PERMIT INFORMATION

Permit Number: C-1981-012 Mine Name: New Elk Mine Operator: New Elk Coal Company, LLC Operator Address: 12250 Highway 12 Weston, CO 81091	County: Las Animas Operation Type: Underground Permit Status: Suspended Ownership: Private
	Operator Representative Present: None
Operator Representative Signature: (Field Issuance Only)

INSPECTION INFORMATION

Inspection Start Date: August 5, 2025 Inspection Start Time: 13:04 Inspection End Date: August 5, 2025 Inspection End Time: 16:36	Inspection Type: Coal Complete Inspection Inspection Reason: Normal I&E Program Weather: Cloudy
Joint Inspection Agency: None	Joint Inspection Contacts:
Post Inspection Agency: None	Post Inspection Contacts:
Inspector(s): Amber M. Gibson	Inspector's Signature:  Signature Date: August 15, 2025

Photo 36: Topsoil piles with signs posted at the site.

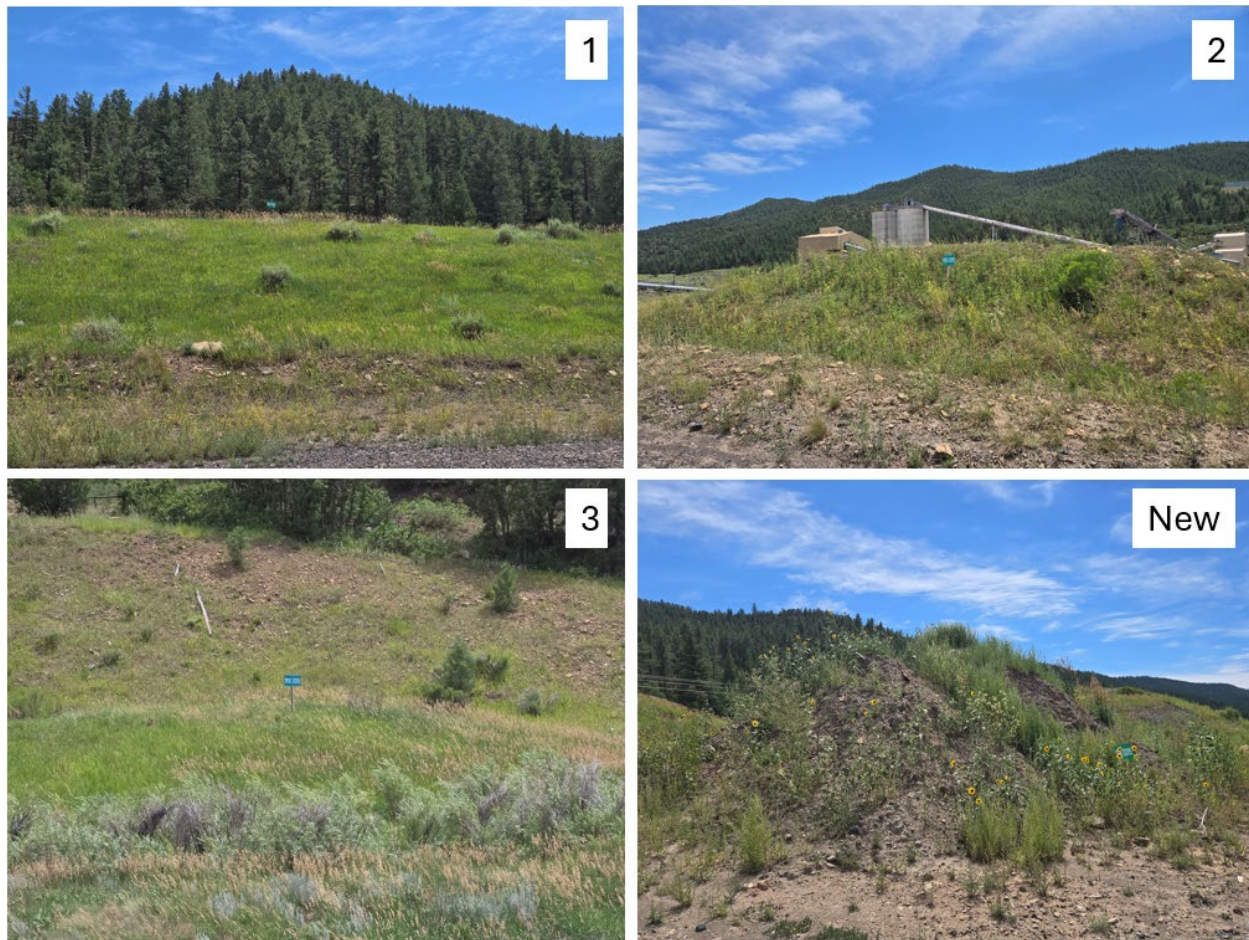
- Signs reading “Topsoil” were posted at topsoil piles #1-#3 and the new pile located near #1 in compliance with Rule 4.02.7.
